MARIPOSA DIVERSION TRAIL CONNECTION DELLYNE TO UNSER

CONSTRUCTION PLANS ALBUQUERQUE, NEW MEXICO

TITLE: **COA TRAILS 2001**
MARIPOSA DIVERSION TRAIL CONNECTION
GENERAL NOTES

TITLE: **COA TRAILS 2001**
MARIPOSA - UNSER CONNECTION
PLAN AND PROFILE

PROJECT NO. **644605** MAP NO. **F-11** SHEET **3** OF **14**

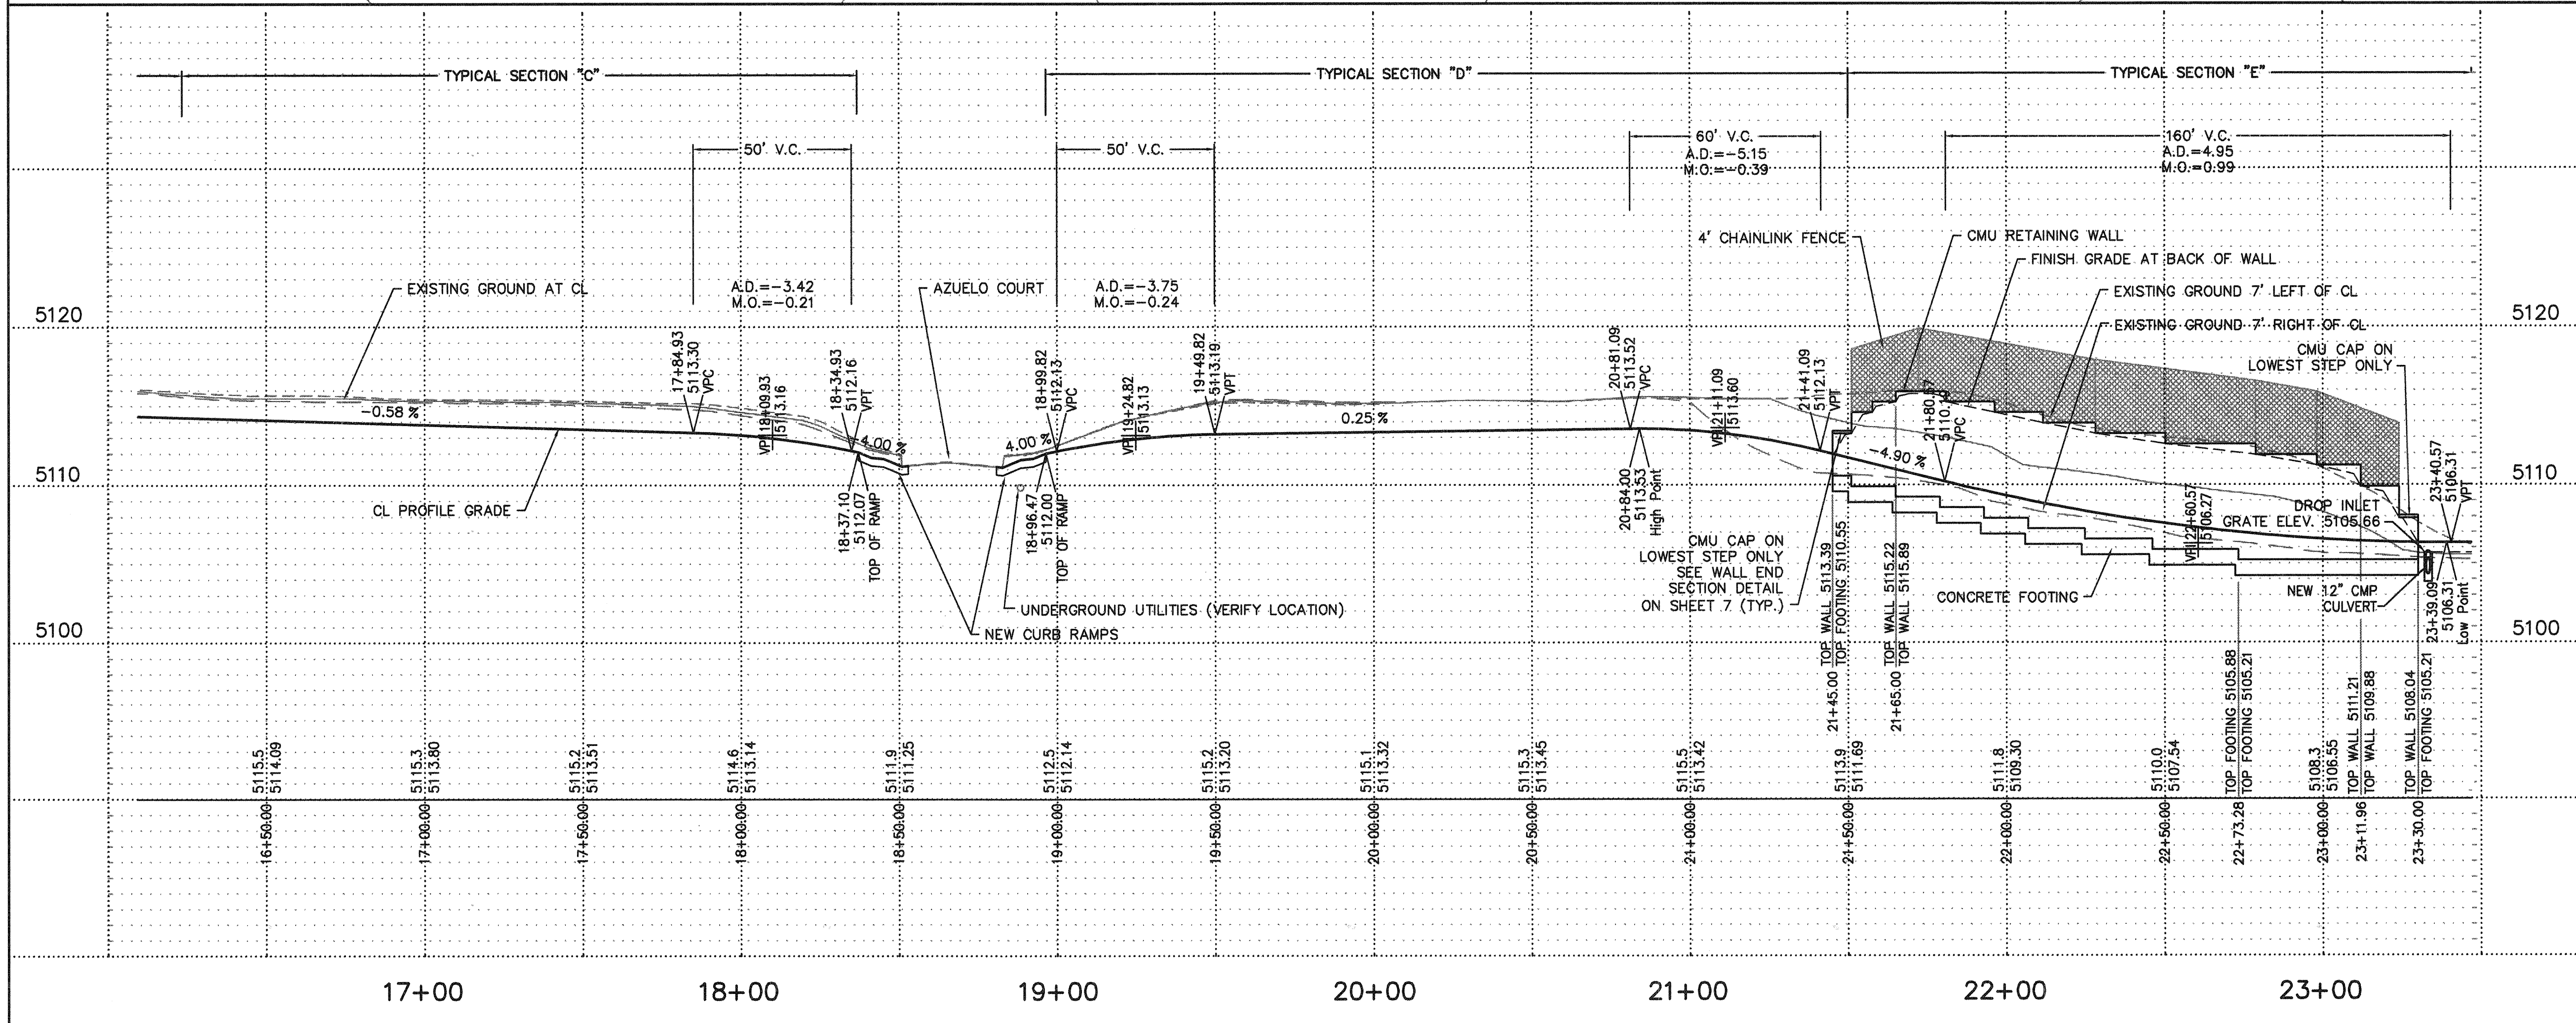
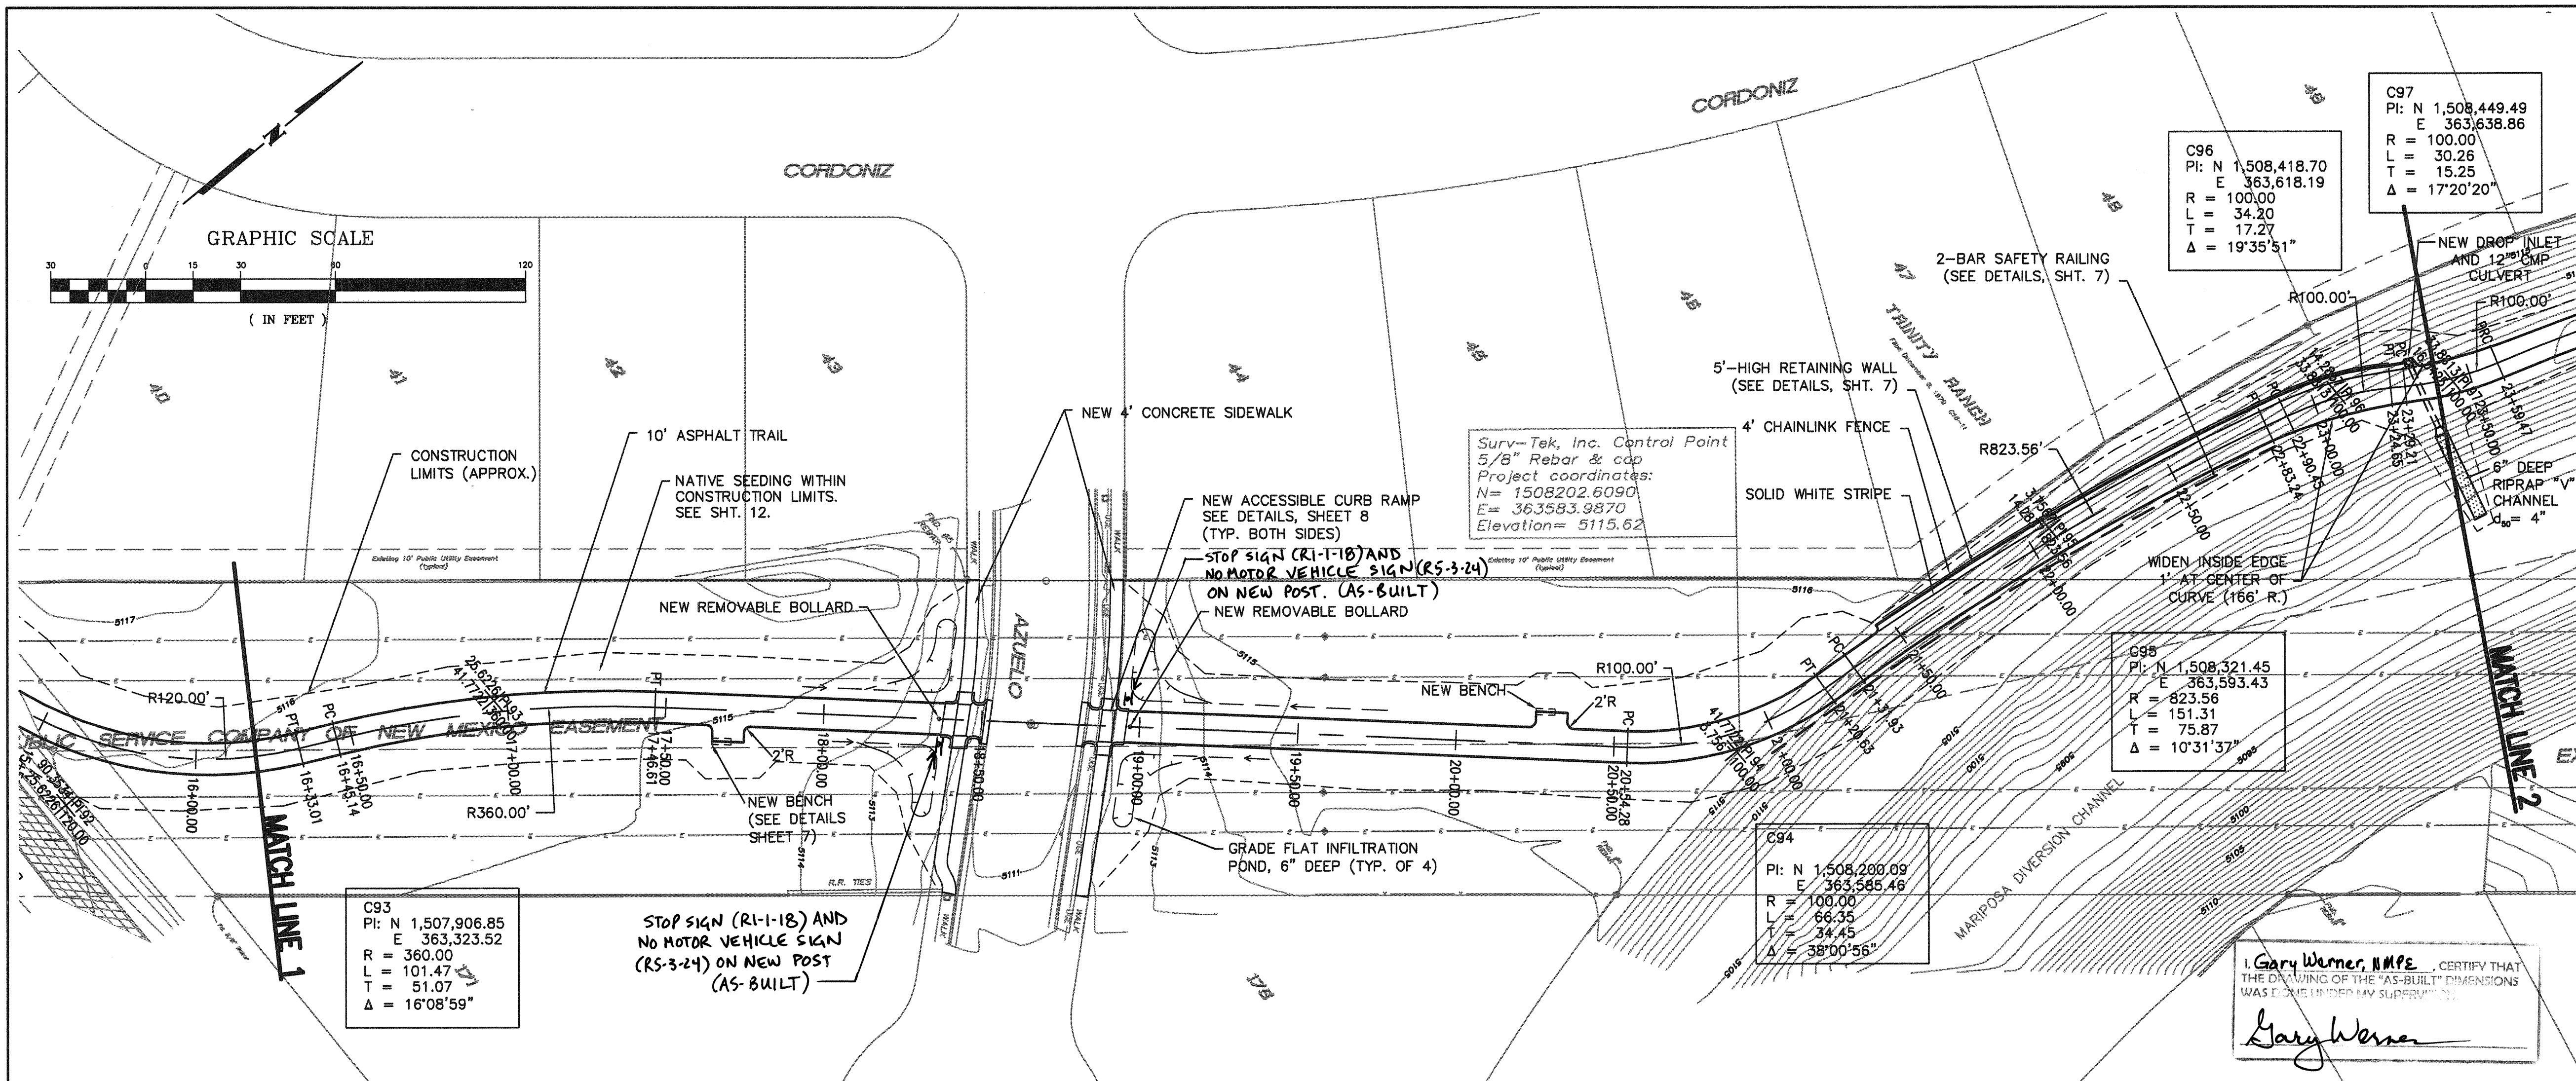
- STOP SIGNS AND NO MOTOR VEHICLE SIGNS ADDED AT AZUELO (STA. 18+40 & 18+95) - AS-BUILT

PROJECT NO. **644605** MAP NO. **E-11 F-11** SHEET **4** OF **14**

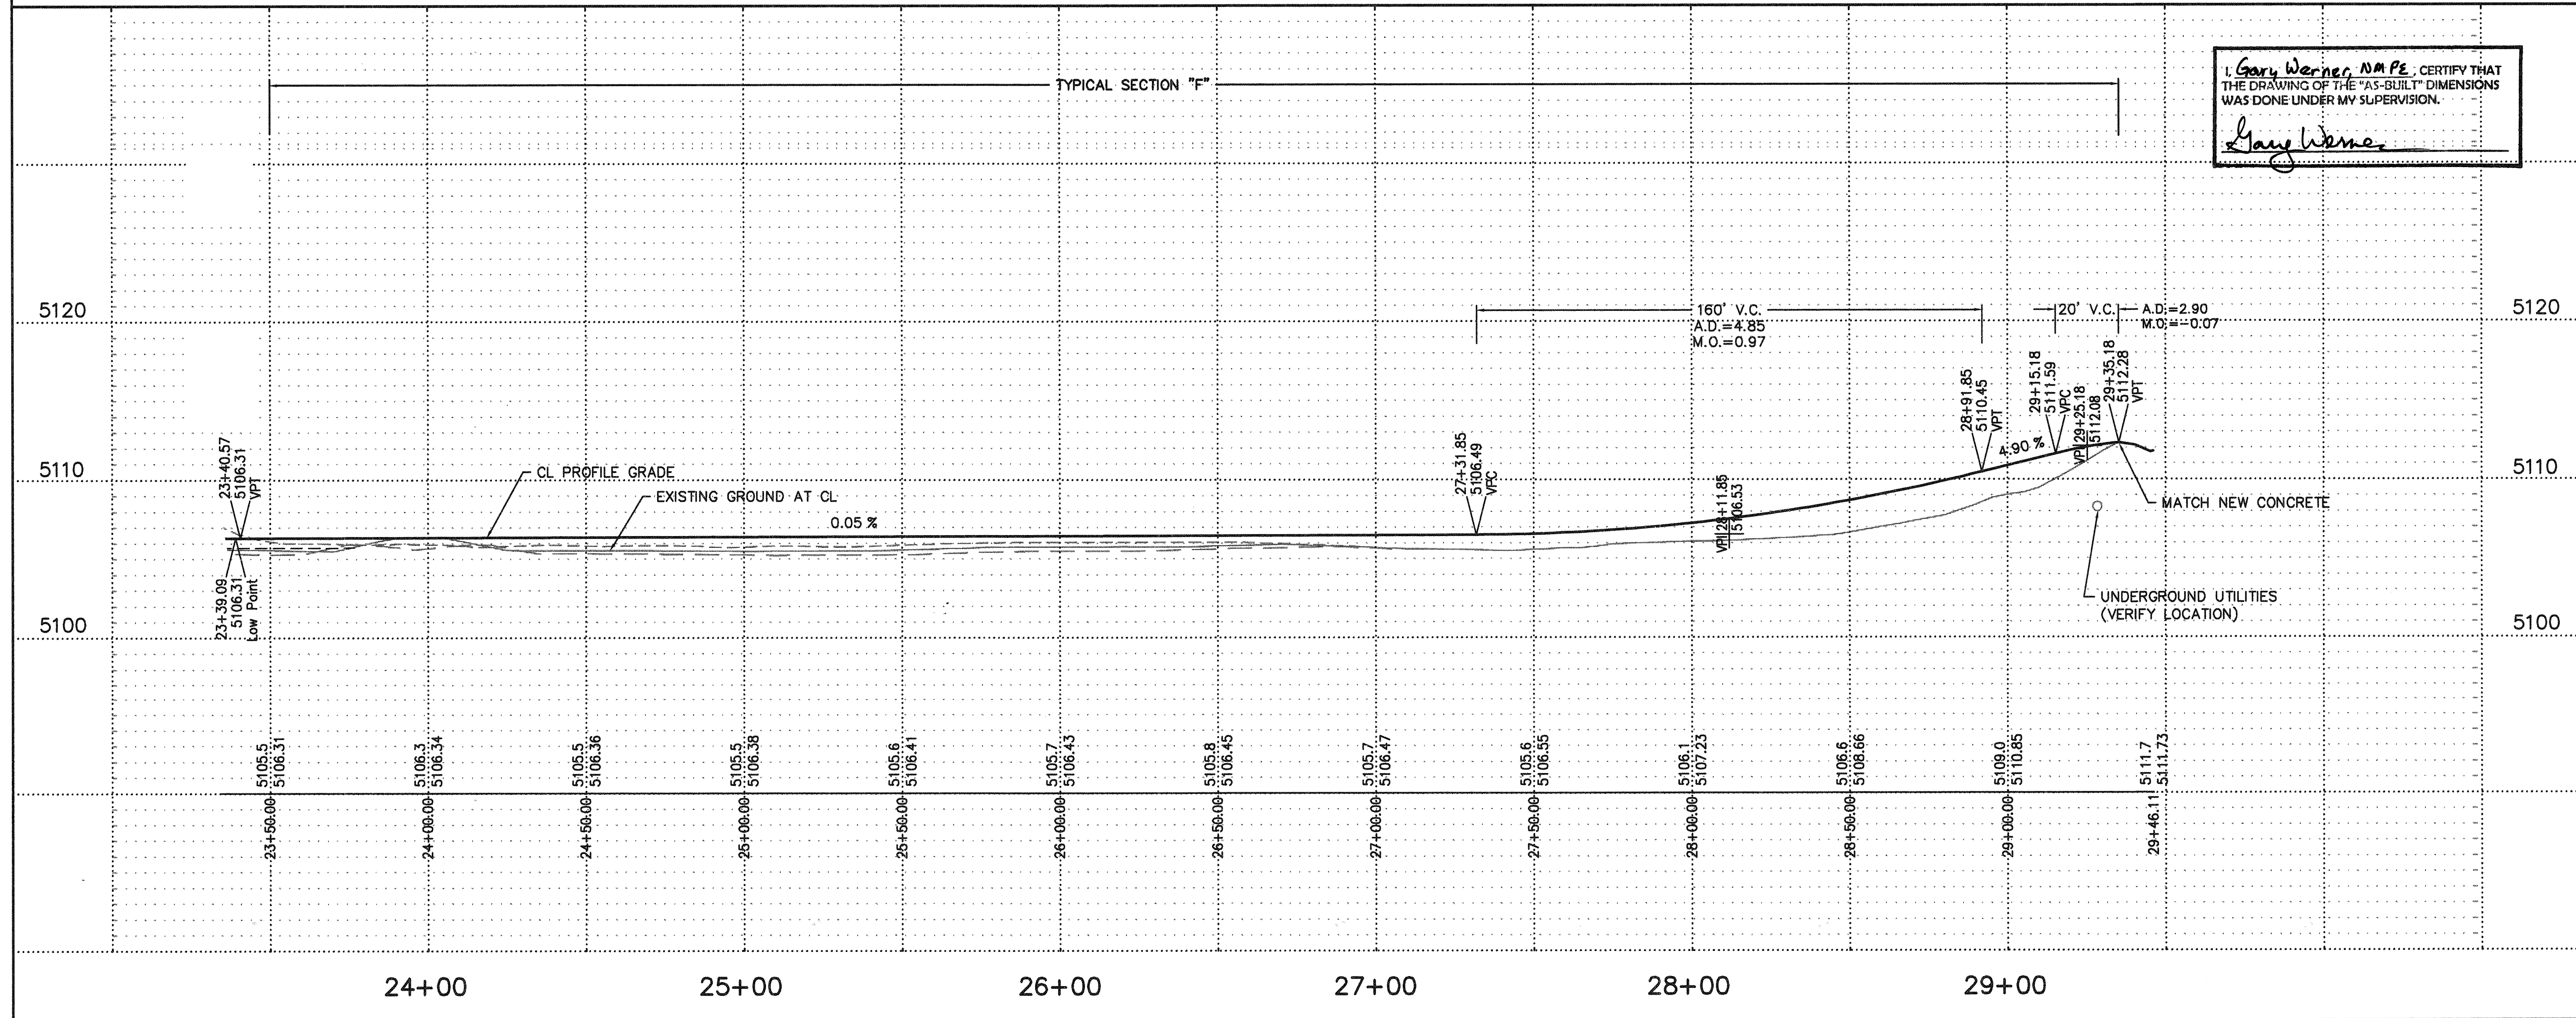
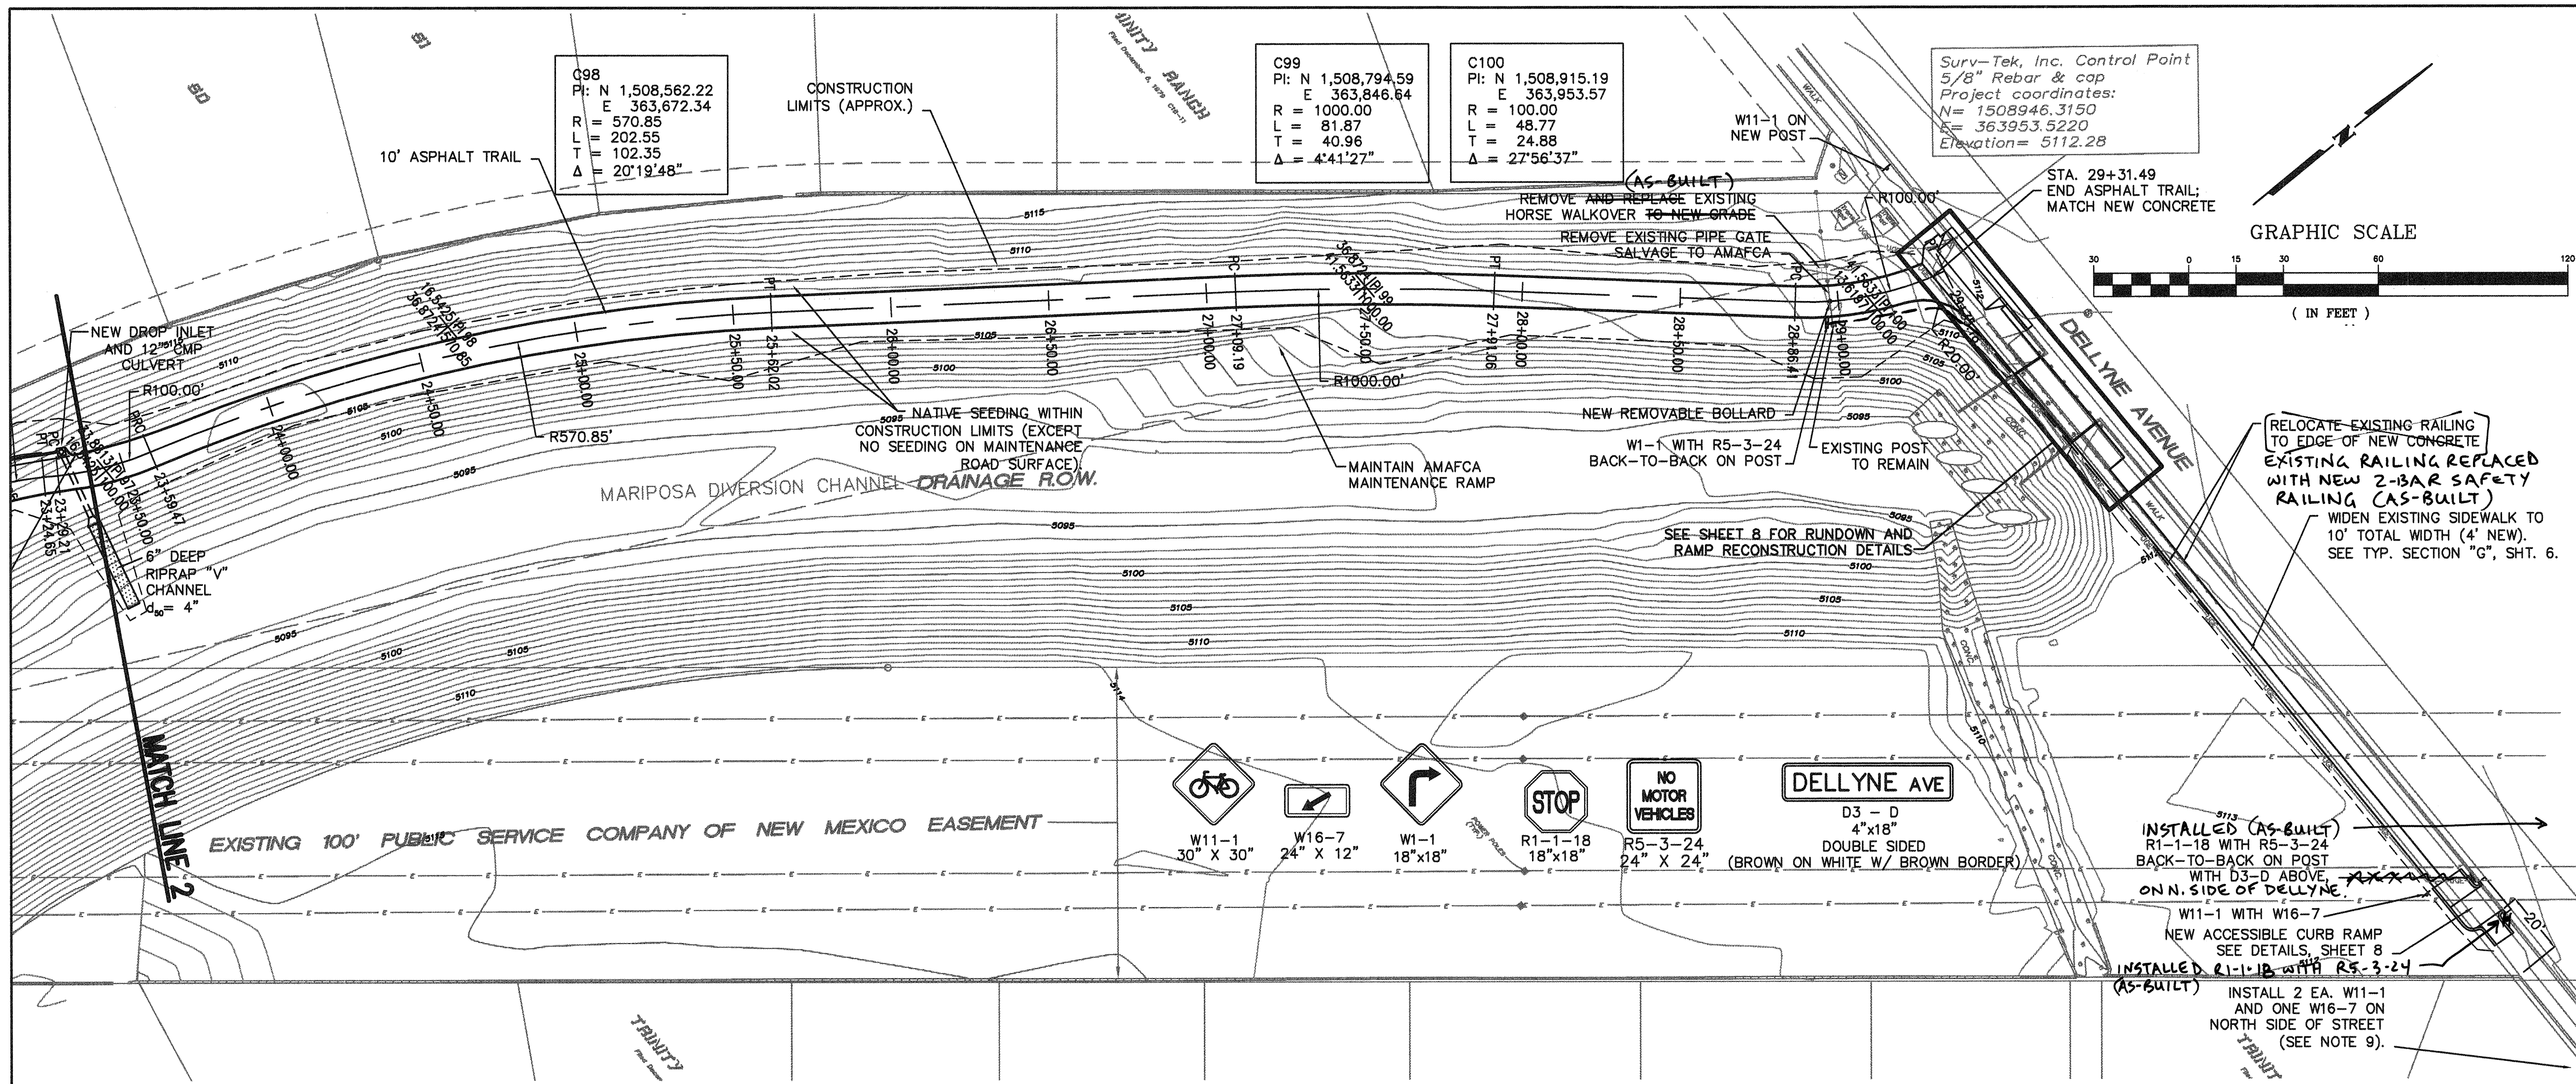
- STA. 28+97 (RT. TO LT.) - REMOVE EXISTING PIPE GATE AND HINGE POST; SALVAGE TO AMAFCA. (LOCK POST TO REMAIN AT EDGE OF CHANNEL). INSTALL NEW REMOVABLE BOLLARD AT CENTERLINE OF TRAIL, PER COA STD. DWG. 2250. REMOVE EXISTING TIMBER HORSE WALKOVER WEST OF GATE, AND REPLACE AT NEW FINISHED GRADE AFTER TRAIL CONSTRUCTION IS COMPLETE. **CNOT REPLACED-AS-BUILT**

- STA. 29+35 (20' RT. TO 82' RT.) - RELOCATE EXISTING PIPE RAILING APPROX. 4' SOUTH; REMOVE EXISTING SIDEWALK RAMP EAST AND WEST OF EXISTING RUNDOWN (TO REMAIN). BUILD 4" CONCRETE SIDEWALK (10' WIDE) AND SUSPENDED RUNDOWN. CROSSING PER DETAILS ON SHEET 8. **EXISTING RAILING REPLACED w/NEW**

- APPROX. 49' 2-BAR SAFETY RAILING INSTALLED (STA. 28+95 RT. TO TIE-IN TO NEW RAILING ON DELLYNE.) **AS-BUILT - SEE DETAIL SHEET 8.**
